**To:** Council **Date:** August 13, 2015  
**From:** Jonathan Tinney – Director, Sustainable Planning and Community Development  
**Subject:** **Rezoning Application No. 00461 and Heritage Alteration Permit No. 00192 for 816 Government Street and 811-813 Wharf Street - Application ready to proceed to Public Hearing**

**6. 816 Government Street/811-813 Wharf Street  
Heritage Alteration Permit Application with Variance No. 00192**

**Re: 816 Government Street  
DESIGN REFINEMENTS SINCE APPLICATION  
IN RESPONSE TO ADP & HAC**

**SOUTH ELEVATION** CONTEMPLATED ALTERATIONS TO WINDOW OPENINGS  
SCALE: 1:200

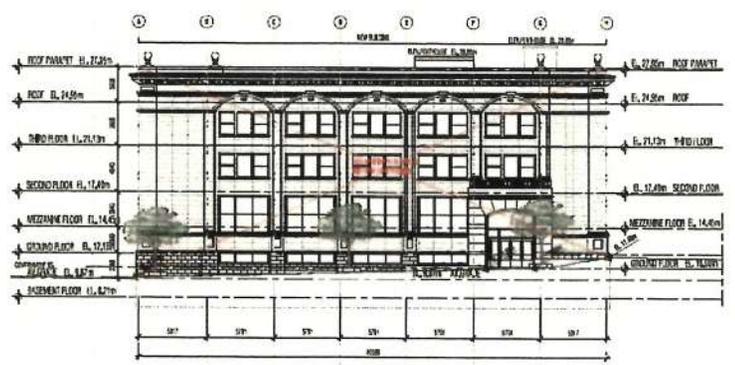
- (d) the proposed exterior alterations and additions to the 1914 Customs House, having special regard to the scope of work anticipated by rehabilitation in the *Standards and Guidelines for the Conservation of Historic Places in Canada*

- Lengthening the windows is a good compromise.
  - Could the carriageway be opened up as it was in the past to speak to its historic use?
  - The extent of alterations is considerable with interventions on each side of the building. The number of perforations in the 1890s foundation is a problem and will involve the raising of lintels and the lowering of sills.

- Height of new addition acceptable, more setback of upper storeys preferred.
- Comments under item d, all make the same point – that the number of “interventions” in the building base is excessive.
- Why parking access in old building wall?
- Scale of new building “at odds” with heritage building. New construction should not dominate.
- Colour of stone of new building questioned.
- Windows should not be same size and design as Belmont and Heritage building. Three horizontal rows would be better.

- In relation to the proposed exterior alterations to the 1914 Customs House, the applicant acknowledges that the original use of the building was deliberately inward looking; therefore, to enhance the retail and pedestrian experience and improve functionality, additional openings in the exterior façade of the building are required. The extent of the proposed openings in the character-defining elements of the Heritage-Registered building has remained as proposed, rather than being reduced as suggested by HAPI.

SIDEWALK VIEWS OF NEW ADDITION  
SCALE 1:200

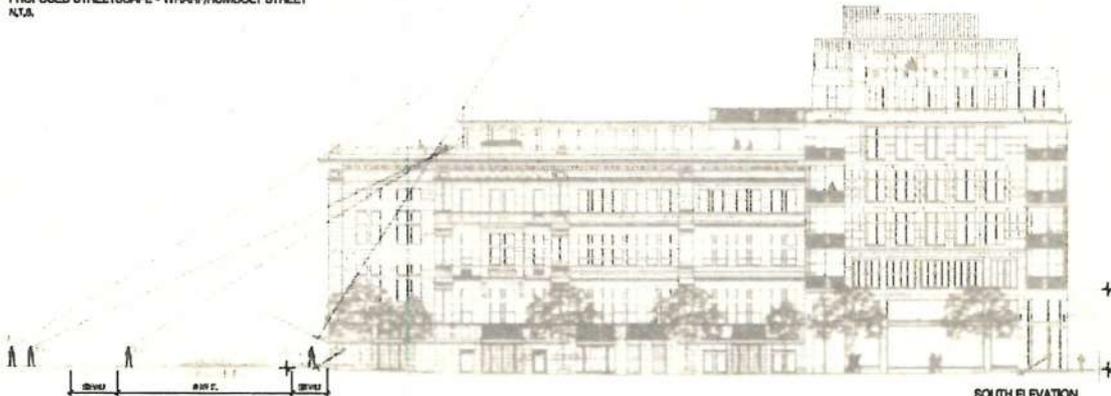
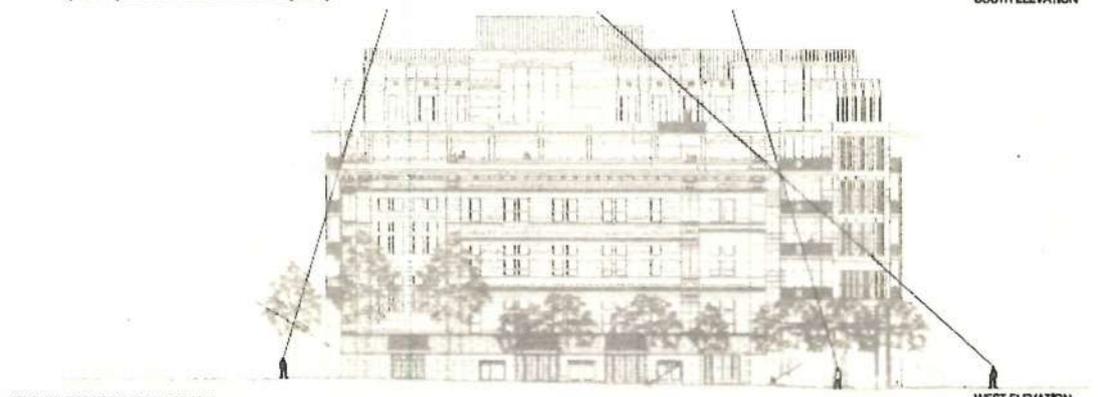
- Regarding the additional setback of the seven-storey addition at the upper storeys, particularly along Government Street, as it relates to the predominant one to five-storey character of Old Town, the applicant has provided a summary of the response in the accompanying letter. This includes stepping back the easternmost portion of the south wall on the seventh storey approximately 3m to align with the existing wall to the west. The revised drawings include sightlines from the street level that demonstrate the extent to which the new addition will still be visible.

- providing visual sightlines on drawing elevations to demonstrate the perception of the building as viewed from the street
- agreeing that, in the event that the purple Beech tree needs to be removed, the tree will be replaced by one with a minimum calliper size of 10cm diameter.

**STREET LEVEL PLAN - PRELIMINARY TREE PROTECTION COORDINATION**

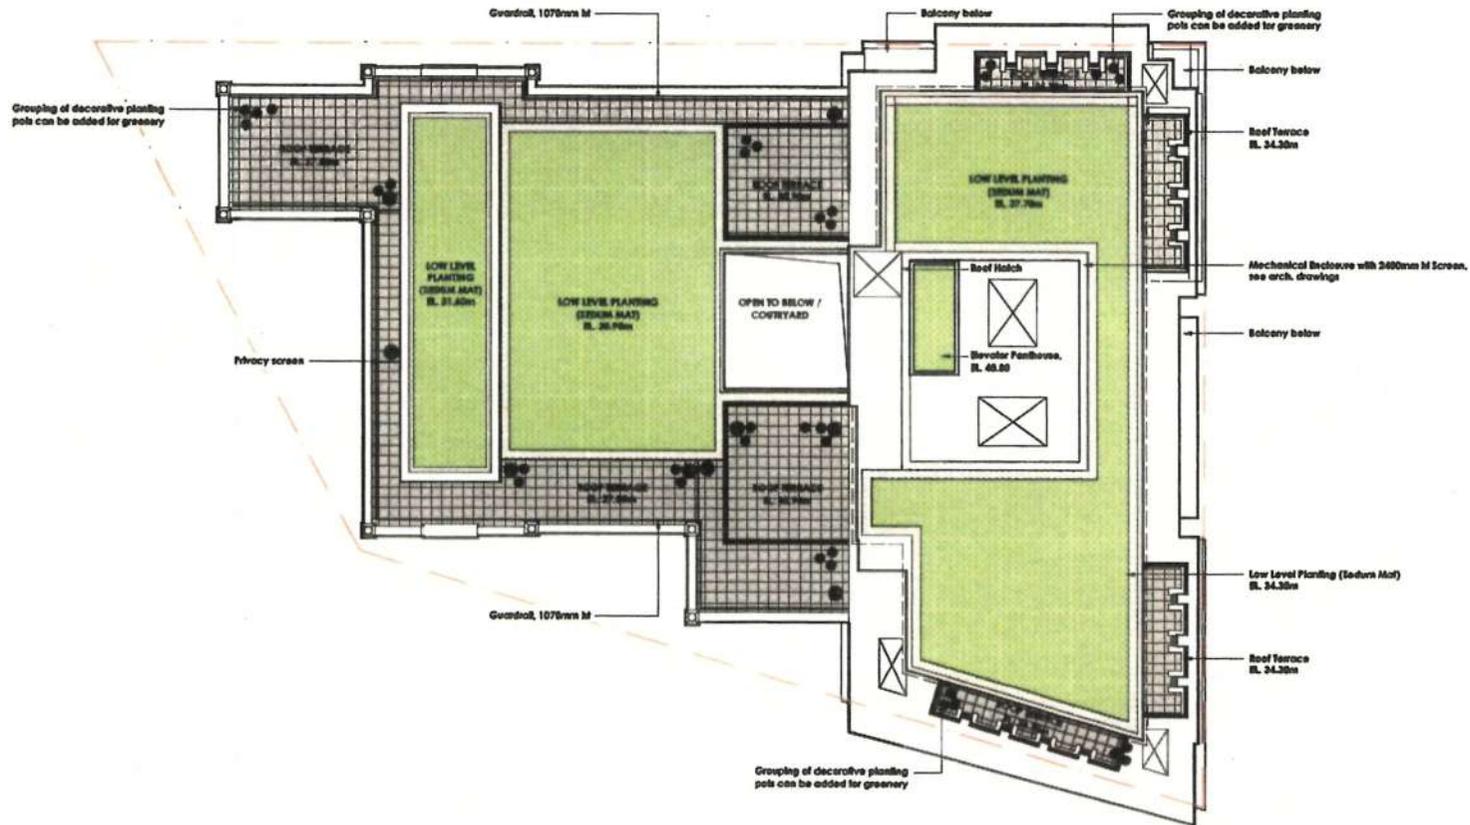
- Panel indicated general support for the height, scale and contextual relationships.
- Suggested building mass articulations could be simplified, particularly the top two floors.
- Panel expressed concern over extent of mechanical penthouse and its access stair.
- Concern over office lobby entrance on Government Street.
- Resolution of glass line at South East corner Government and Wharf Street queries.
- Retentions of purple Beach on Wharf Street west side questioned.
